CONSULTANT ASSESSMENT REPORT

| DA No: | DA/389/2023 (Lodged on 10 May 2023) |
| Description: | Alterations & Additions to an existing child care centre |
| Property: | Lot 2 DP 565080, No. 1 Hall Road, Hornsby |

Figure 2-2 Additions & Alterations to the existing Child Care Centre Child Care Centre Layout (Ground Floor)

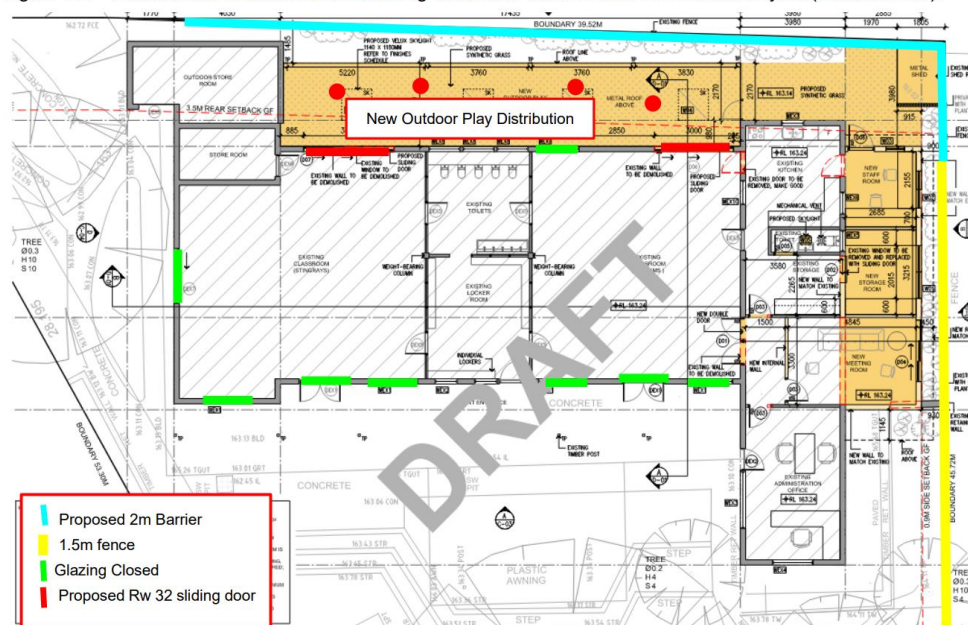
The figure above indicates the fence along the southern boundary and part of the western boundary (shown blue in the figure) is 2m, however the recommendations of the report are for the fence to be 2.1m in height. The correct height has been reinforced by recommended conditions of consent.

There is a discrepancy regarding the use of this western side area which is only 0.9m wide from the edge of the addition to the boundary. The Proposed Ground Floor Plan B-02 indicates plants within this area, where as the Elevations and Sections indicate a flat area and no planting. Given there is an elevated landscaped area along the boundary above the retaining wall currently, it is expected that this retaining wall and existing landscaping would need to be removed to accommodate the addition and that the Elevations and Sections more accurately depict a flat area which would be used for maintenance, consistent with the written documentation. The new boundary fence along the western

- a) Install 2.1 metre high solid barrier along the south boundary to mid position of the west boundary as demonstrated in Figure 2-2.
- b) The windows are to be configured as shown in Figure 2-2. Glazing for sliding doors and window on the southern exterior façade must have a minimum Rw32.
- c) Install sound absorptive material to at least 50% of the ceiling/roof area above the outdoor play, with a minimum rating of NRC 0.7.

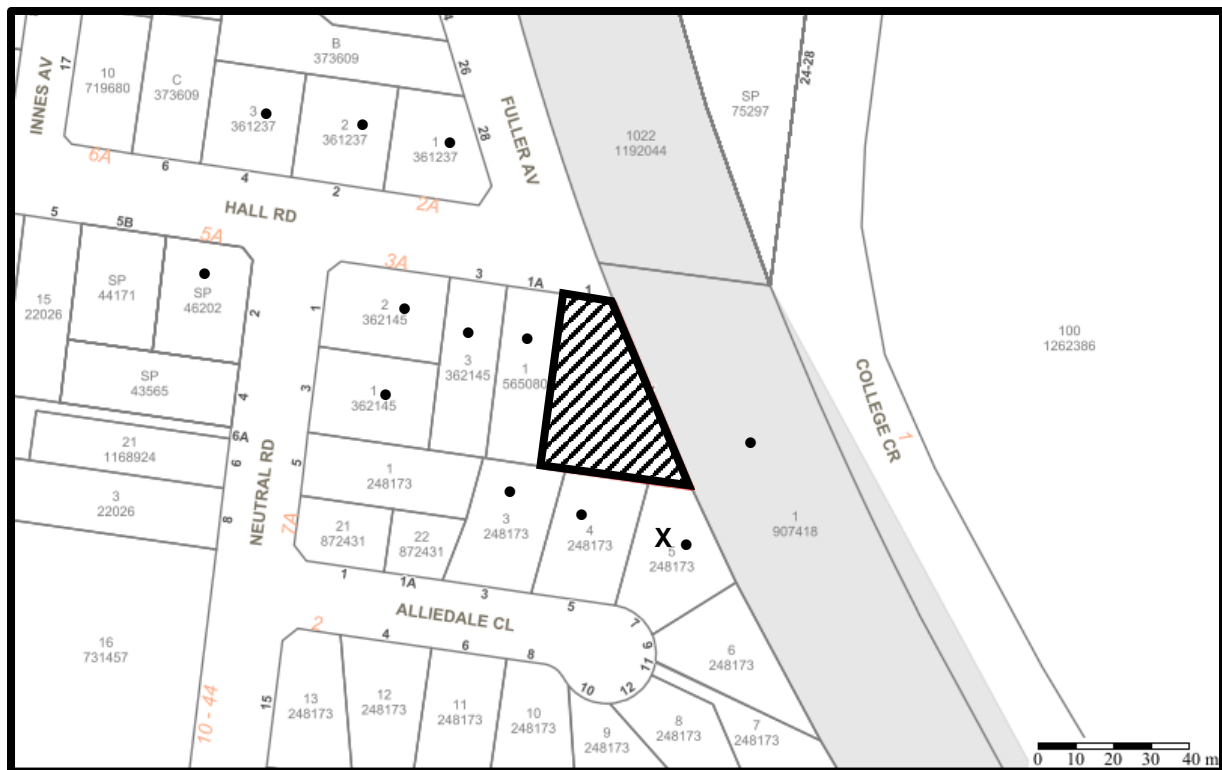
New boundary fencing along the southern and western boundaries is required in accordance with the Acoustic Report and this will resolve the current opening in the boundary fencing along the southern boundary. A condition of consent has been included to ensure this issue is rectified.
